April 15, 1983
AEP:NRC:0637M

Donald C. Cook Nuclear Plant Unit No. 2
Docket No. 50-316
License No. DPR-74
UNIT 2, CYCLE 4 SAFETY EVALUATION REPORT:
RESPONSE REGARDING PLANT TRANSIENT METHODS

Response to the Plant Transient Analysis
Issues Identified in the NRC Safety
Evaluation Report (SER) for D. C. Cook
Unit 2, Cycle 4

16-22-16.

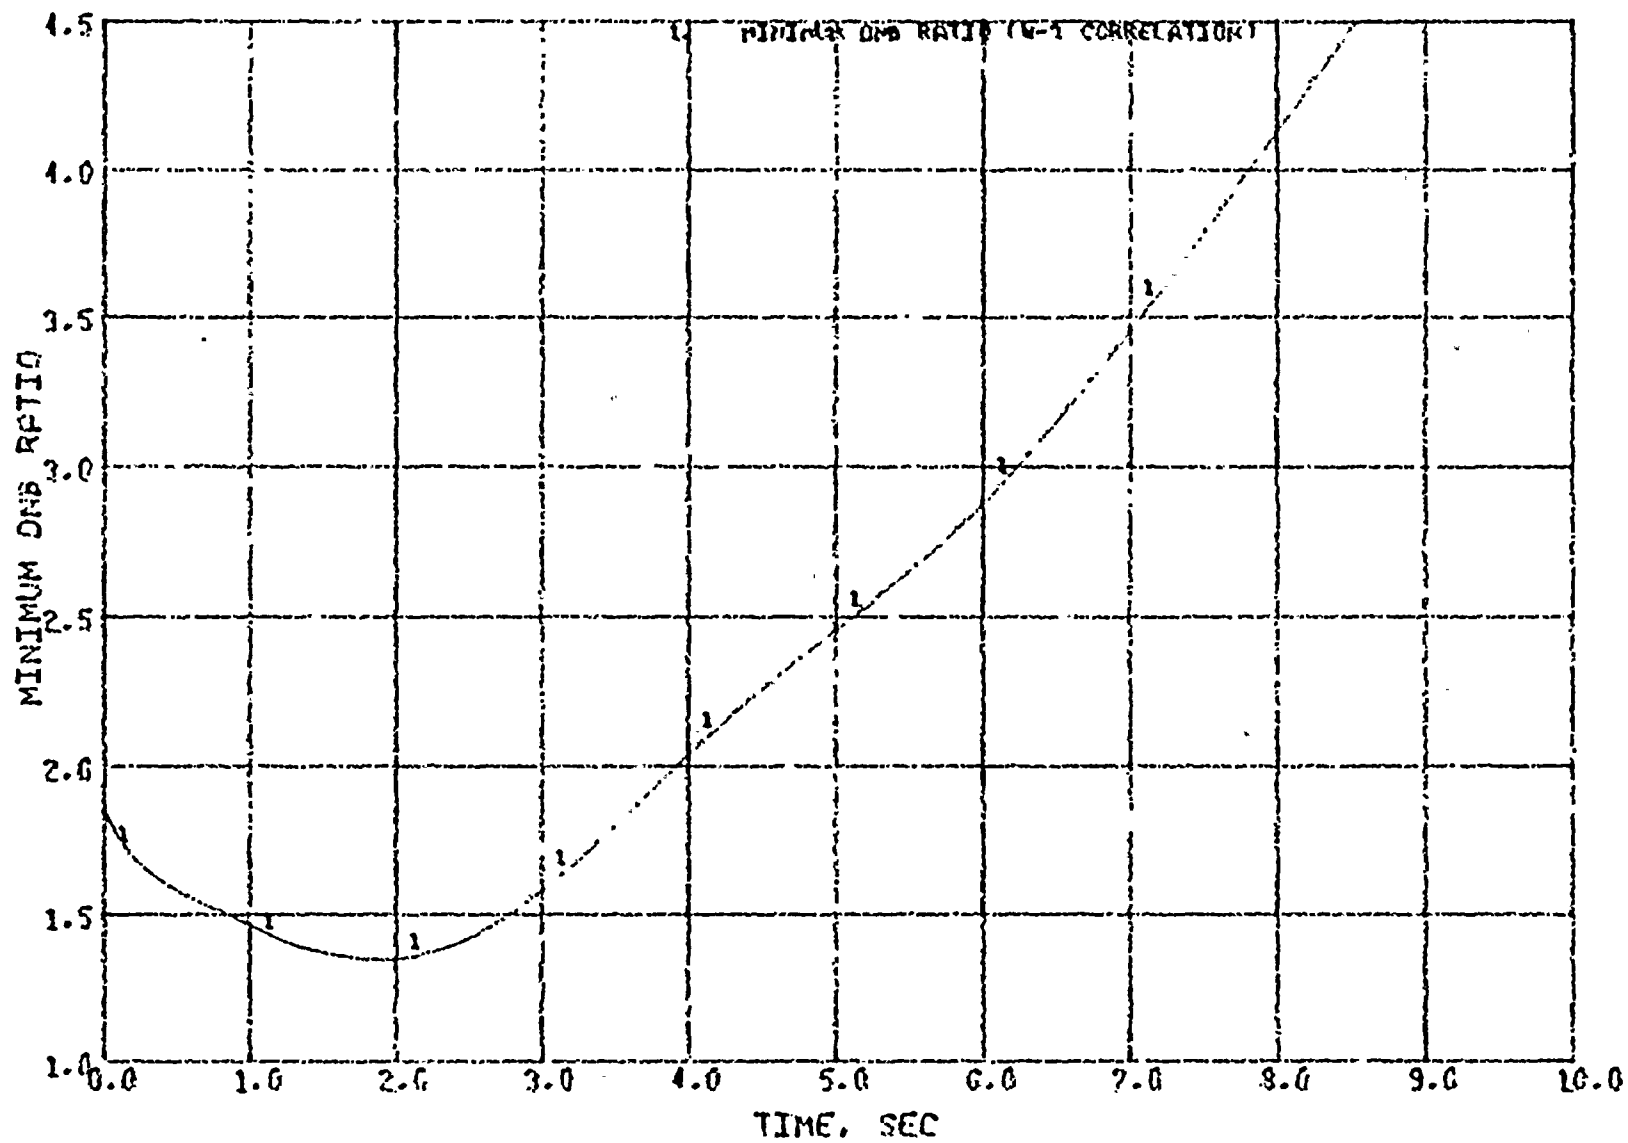
Item 1.2: Provide a confirmatory analysis which demonstrates that specified acceptable fuel design limits are not violated for the case of loss of offsite power. Justification for any delays assumed between reactor/turbine trip and loss of offsite power must be provided.

The requested simulation is attached. Inputs and methodology are identical to those used in Case 1, reported in XN-NF-82-32(P), Rev. 1, except that coastdown of the three remaining primary coolant pumps is assumed to occur simultaneously with the occurrence of the locked rotor. No delay is assumed between reactor trip and loss of offsite power. The calculated MDNBR is 1.34, only slightly degraded relative to the locked rotor case 1. Attached Figures 1-6 display the calculated system response.
